SUBJ: LIGHT LEVELS IN ENGINEERING LIBRARY

Engineering Library - Lighting Survey

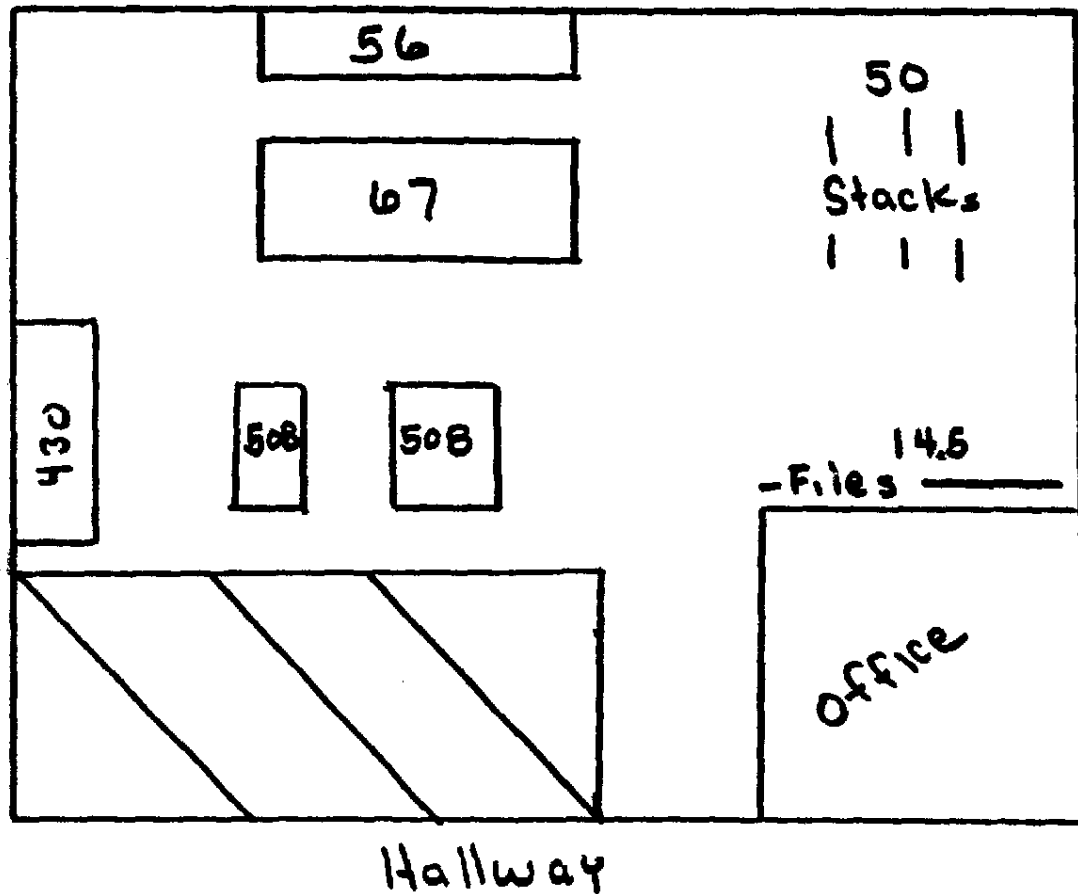
At the request of employees, I measured the light levels in the engineering library to determine if they met recommended guidelines for this type of work location. The recommended level for this area is 100 foot candles. None of the areas surveyed currently have this level. Attached is a rough sketch of the work area and measured levels.

I recommend that the light levels be increased in this work area by whatever means is most practicable.
